From: Woodlan, Don [Donald.Woodlan@luminant.com]
Sent: Tuesday, August 02, 2011 12:33 PM
To: Otto, Ngola
Cc: Monarque, Stephen; Conly, John; ComanchePeakCOL Resource; Evans, Todd; Bird, Bobby; nicholas_kellenberger@mnes-us.com; 'tapia_joseph@mnes-us.com'; russell_bywater@mnes-us.com
Subject: 2011-08-02 Woodlan, Comanche Peak Chapter 8 - Draft ACRS Presentation
Attachments: 2011-08-02 DRAFT R-COLA Chapter 8 ACRS (Luminant) Slides.pptx

Comanche Peak Nuclear Power Plant, Units 3 and 4

ACRS, US-APWR Subcommittee

FSAR Chapter 8 – Electric Power

08.01-1 Sharing of SSCs (Open Item)

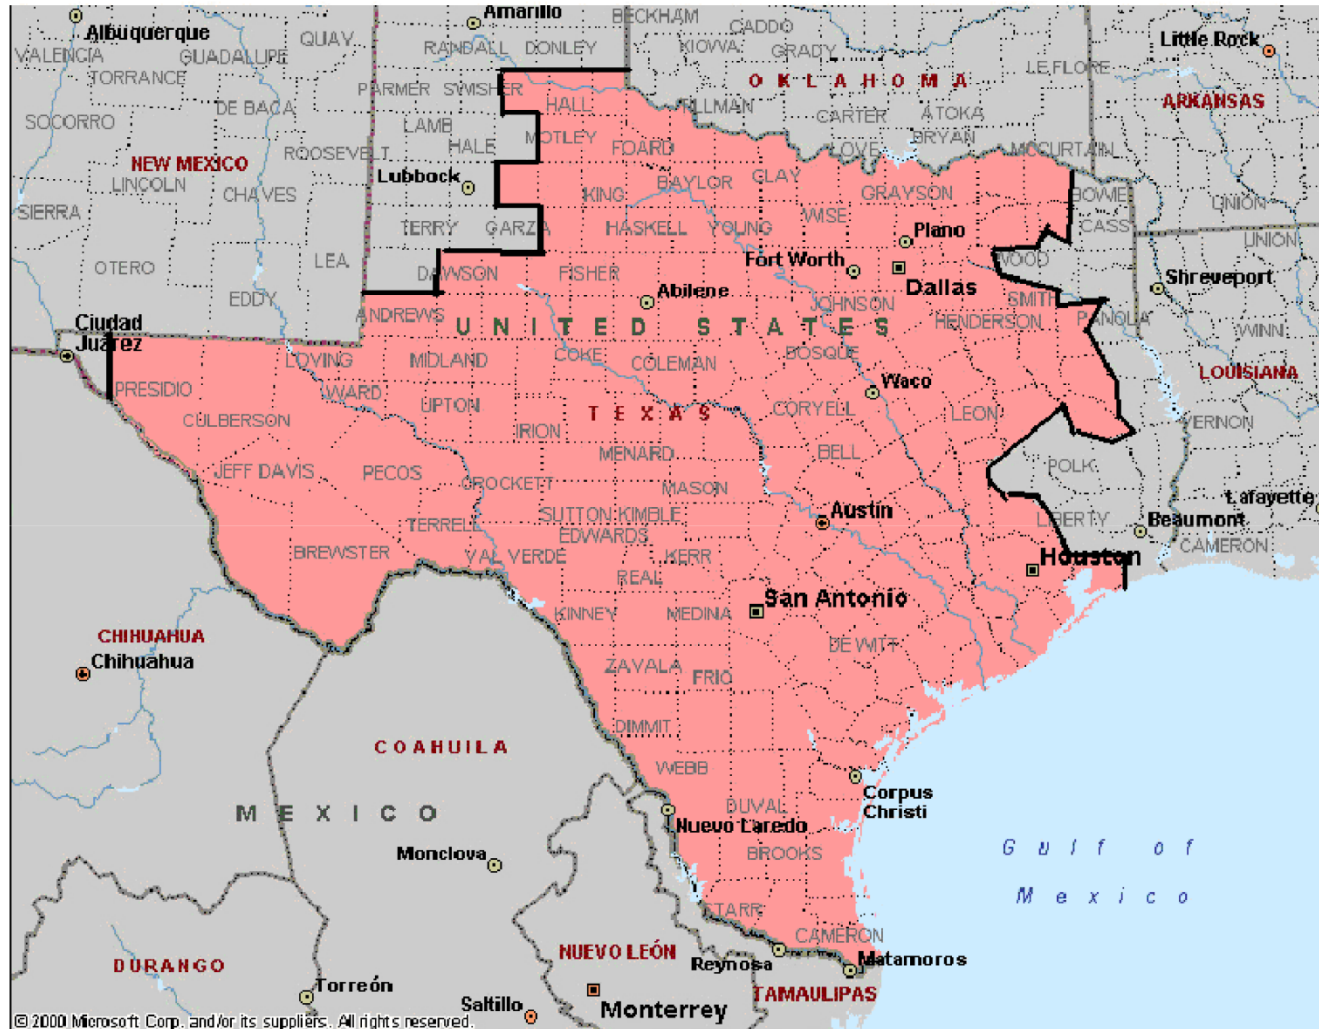
- ❑ **Open Item 08.01-1 related to CP RAI 9 (RAI 2576) Question 08.01-2**
 - **“However, the applicant has not demonstrated whether or not the SSCs important to safety that are shared among nuclear power units will not significantly impair their ability to perform their safety functions, including an accident in one unit, and orderly shutdown and cooldown of the remaining units.”**
 - **RAI 9 was supplemented on August 8, 2011 to address this Open Item. The supplement notes that the switching station equipment shared between Unit 3 and 4 has the capacity and is configured such that sharing will not significantly impair the ability to provide offsite power in response to an accident in one unit, and an orderly shutdown and cooldown of the remaining unit.**
